## MEC170x Silicon Errata and Data Sheet Clarification

# MEC170x

FIGURE 1: HIGH IBAT CURRENT DURING COIN CELL INSERTION

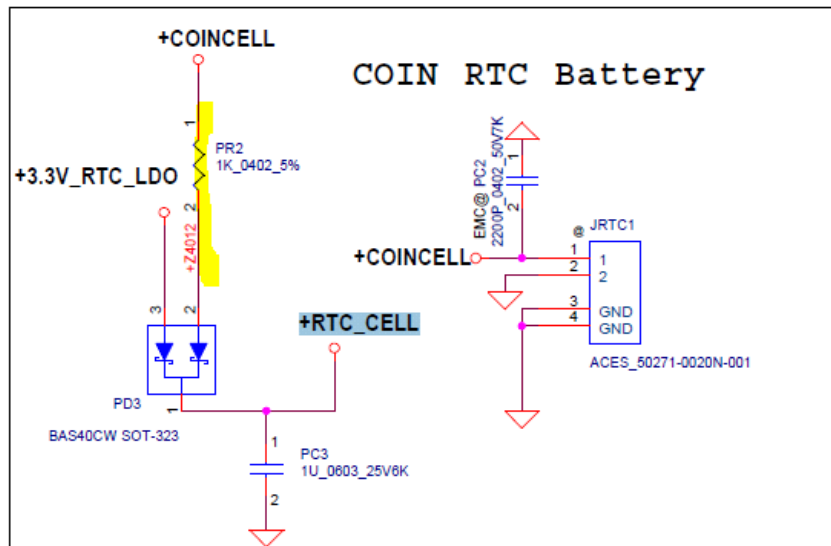
There could be a high  $I_{BAT}$  current on new coin cell insertion. During initial VBAT power rising, the VBAT circuit can enter a high current state causing a voltage drop across the 1K UL resistor. This affects all 128 and 144 pin packages. This issue is not present in the 169 pin packages.

- Under these conditions, the VBAT power on can stall in this high current state, with the VBAT on device pin between 0.7 and 1.2V.

Insert the coin cell and then apply VTR (i.e +3VALW). This enables VBAT low-power operation. A high  $I_{BAT}$  will not return on subsequent VTR power cycles.

Referring to the RTC Battery circuit shown in [Figure 1](#), applying VTR via the +3.3V\_RTC\_LDO signal, powers RTC\_Cell (which is connected to VBAT of MEC5105/6) directly (without a series 1k resistor and hence no IR drop from the applied VTR), raising VBAT (RTC\_Cell) to greater than 2.0 volts. This takes VBAT out of the "high current" region discussed above enabling normal VBAT low power operation.
